# How long will PolyMet need to treat water?

*The Supplemental Draft Environmental Impact Statement (SDEIS) does not reveal what PolyMet, the Minnesota DNR, and the federal agencies know about the length of time over which contaminated water from the NorthMet mine will need to be treated in order to meet water quality standards.*

**Estimated Long-term Copper Concentrations in the West Pit**

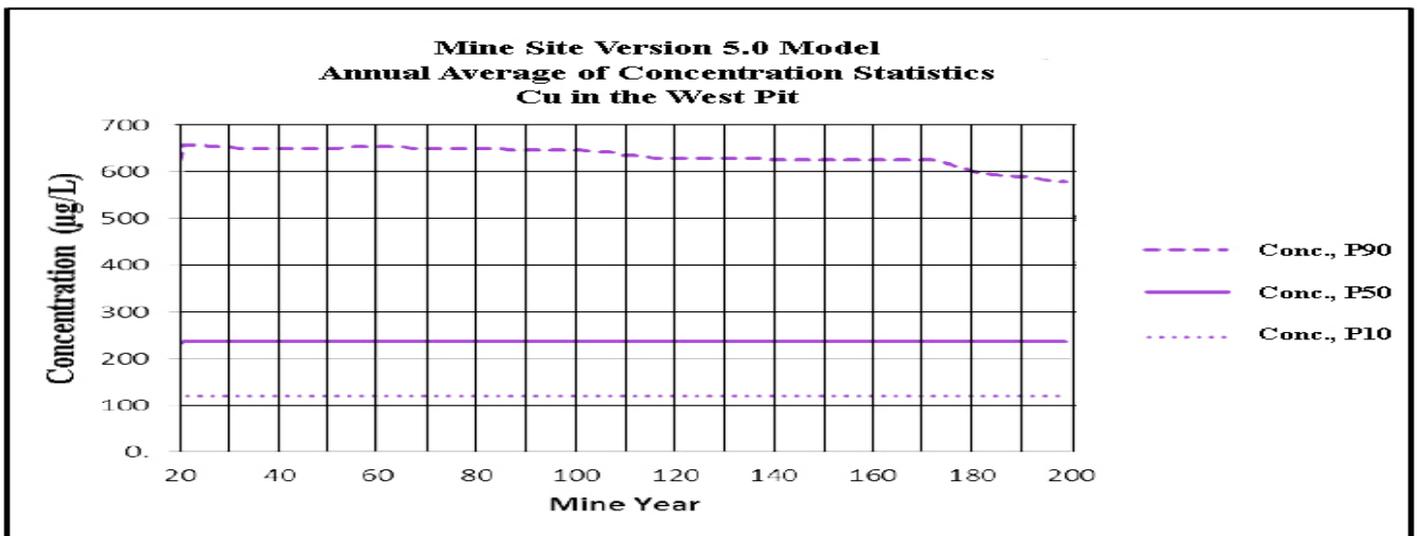
**T**he graph from PolyMet’s “Water Modeling Data Package Vol. 1” (back page, bottom) shows the predicted level of copper in the West Pit “lake” after the mine closes. This is water that will spill out of the lake and form a surface tributary to the Partridge River if it is not collected and treated. The water quality standard for copper in the Partridge River is likely to be 9.2 µg/L. This graph indicates that the discharge may *never* meet the standard for copper.

**T**his example is representative of predictions for a number of pollutants at both the mine site and the tailings basin. These predictions were not

included in the SDEIS itself, nor does the SDEIS include any information about the quality of the water that would be released to the Partridge and Embarrass Rivers, and ultimately to the St. Louis River and Lake Superior, if treatment does not continue indefinitely.
